TS 3-14 03313(R) MODIFICATION OF AUTOMATIC TRANSMISSION CONTROLLER

1992 Suzuki Swift

TECHNICAL SERVICE BULLETIN

Model June 1992 and later Suzuki (except GT)
Division Automotive
Category Technical
Section Drivetrain
Bulletin No. TS 3-14 03313(R)

Fig. 1: A/T Controller Name Plate

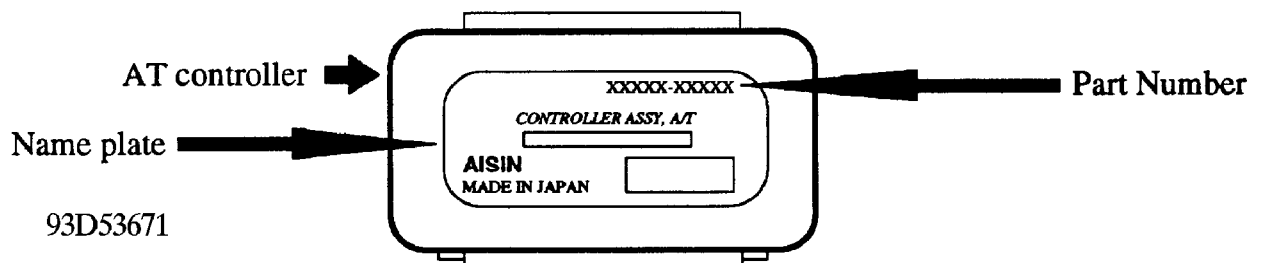
To identify the early or the late type AT controller, check the part number on the name plate as shown in Fig. 3.

Part Name	Early Part No.	Late Part No.	#	Supply of Spare Parts	Interchangeability
A/T controller	388861E00	388861E40	1	Late only	Early<->Late

Fig. 2: Original A/T Shift Diagram

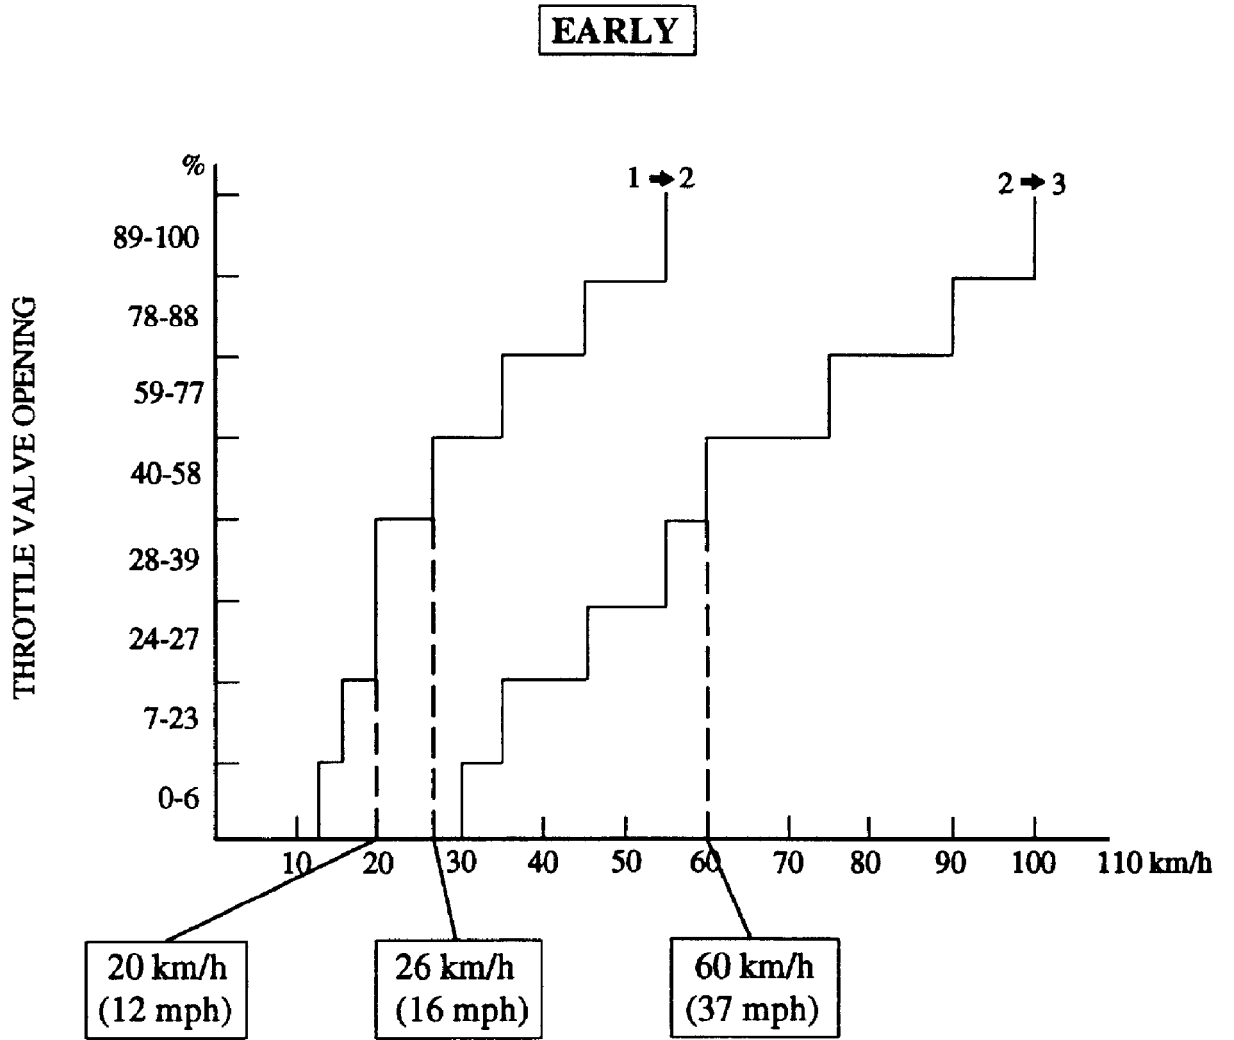
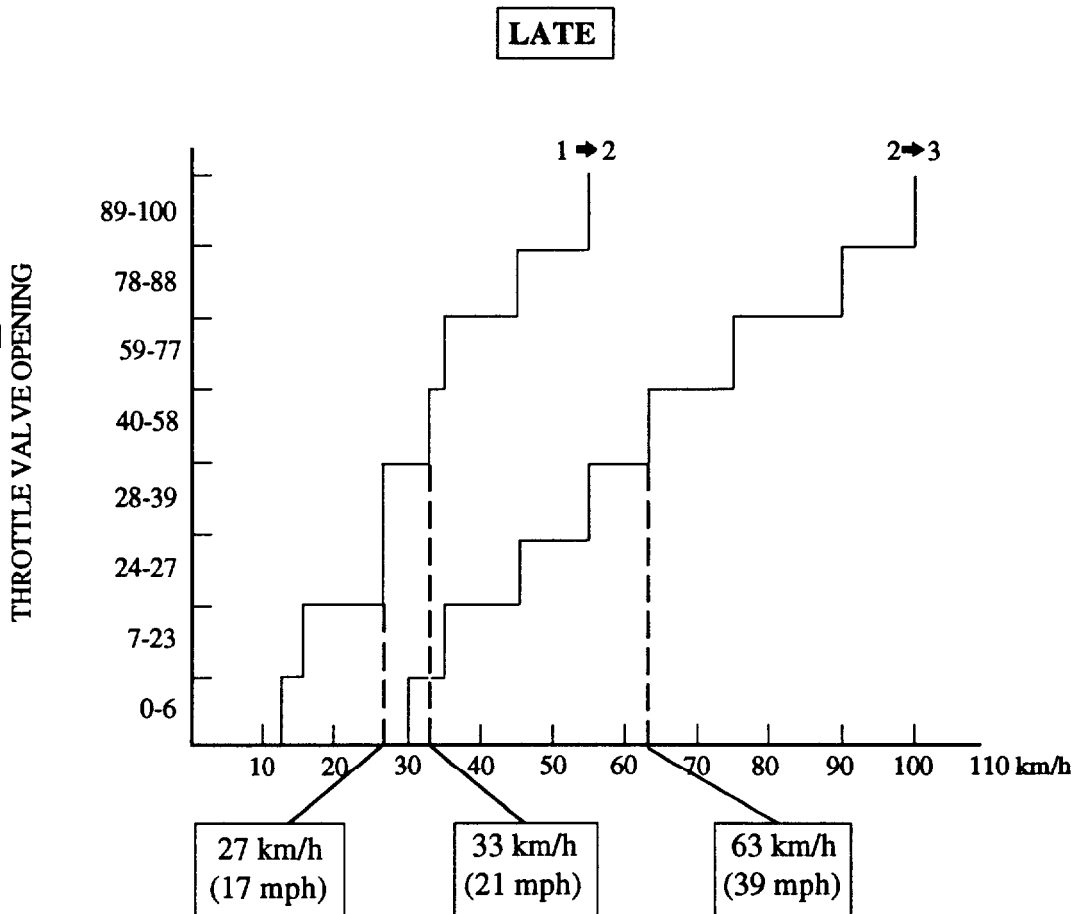
This bulletin is to inform you of the modification of the A/T controller which has been carried out since June 1992 production. Due to the modification of the AT controller, the A/T shift diagram has also been changed. See Figs. 1 and 2.

Fig. 3: Revised A/T Shift Diagram
